Access Compliance Report Public Rights-of-Way (Curb Ramps)

Intersection ID: 4250 Main Street: RADBOURNE_BV Cross Street: SYMPHONY_WOODS_DR Location: E

ADA ID: 229445BC0188 Ramp Type: Perp Initial Pass/Fail: Fail Overall Compliance: No Severity Score: 25

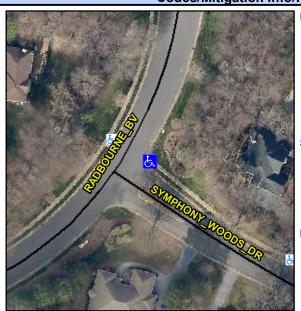
R304.5.3

Field Measur	ements/C	<u>ompo</u>	nent Compliance	
Compliance Description		Data	Comp	liance Description	Data
N/A	Ramp Length (in)	92.5	Yes	Ramp Slope (%)	6.7
Yes	Ramp Width (in)	48.0	No	Ramp XSlope (%)	11.9
N/A	Flare Type LT	N/A	N/A	Flare Type RT	N/A
N/A	Flare Slope LT (%)	N/A	N/A	Flare Slope RT (%)	N/A
N/A	Flare Traversable LT?	N/A	N/A	Flare Traversable RT?	N/A
N/A	Landing Length (in)	N/A	N/A	DWS Provided?	N/A
N/A	Landing Width (in)	N/A	N/A	DWS Contrast?	N/A
N/A	Landing Slope (%)	N/A	N/A	DWS Length (in)	N/A
N/A	Landing X Slope (%)	N/A	N/A	DWS Full Width?	N/A
N/A	Landing Curb? (Y/N)	N/A	N/A	DWS Offset (in)	N/A
N/A	Shared Landing?	N/A			
N/A	Gutter Ponding?	N/A	N/A	Gutter Slope (%)	N/A
N/A	Gutter Lip Ht (in)	N/A	N/A	Gutter X Slope (%)	N/A
N/A	Painted X Walk1?	No	N/A	Painted X Walk2?	N/A
	X Walk 1 Direction	To NW		X Walk 2 Direction	N/A
N/A	X Walk 1 Width (in)	N/A	N/A	X Walk 2 Width (in)	N/A
	X Walk 1 Slope (%)	0.4		X Walk 2 Slope (%)	N/A

Remove & Replace Entire Ramp.
